ADDENDUM NO. 1 TO PROJECT NO. 41135

CONSTRUCTION WORK, HVAC WORK, PLUMBING WORK and ELECTRIC WORK
CONSTRUCT MAINTENANCE SUBHEADQUARTERS
BUILDING NO. 4
DOT REGION 8, WESTCHESTER COUNTY
ROUTE 100, MILLWOOD, NY 10546

February 20, 2015

FRONT ELEVATION

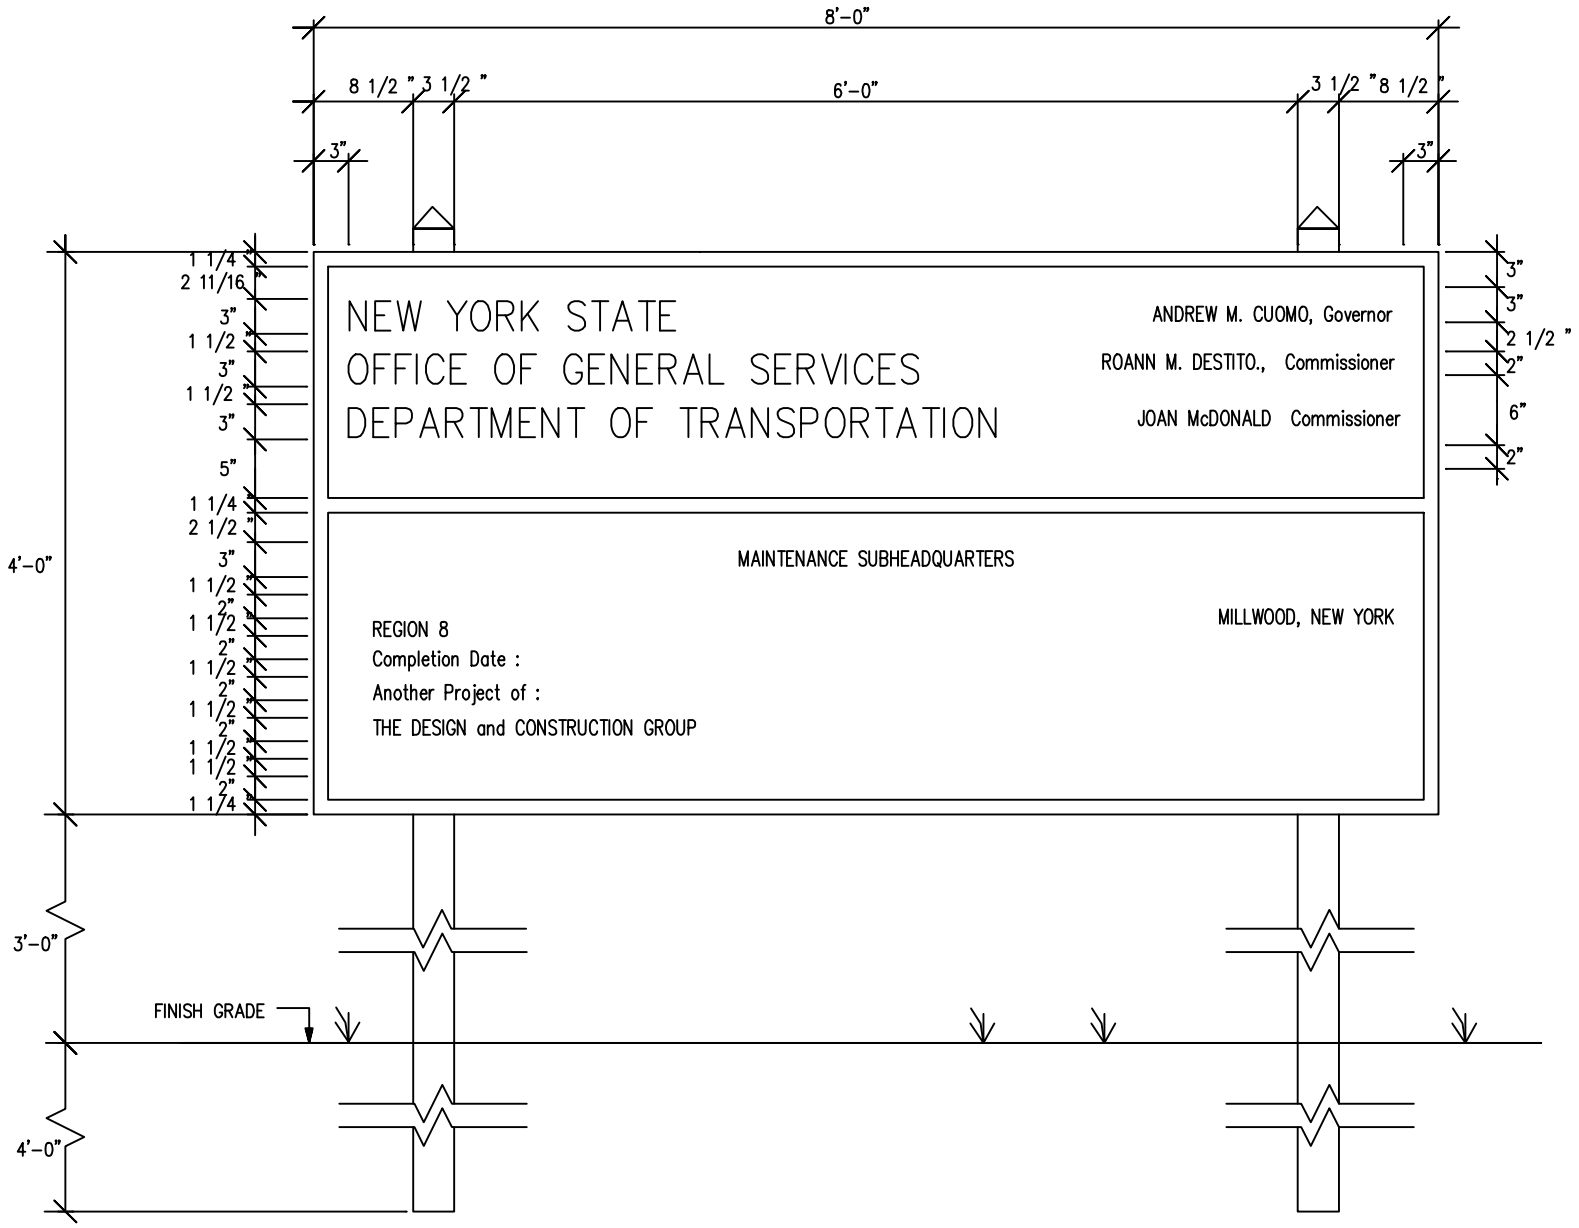
8. 015813 PROJECT IDENTIFICATION SIGN**:** Delete Page 3 Front Elevation dated 07/18/2008 enclosed in the project manual and add Page 3 Front Elevation Dated 2/19/2015 attached, to the project manual and forms a part of the contract documents.
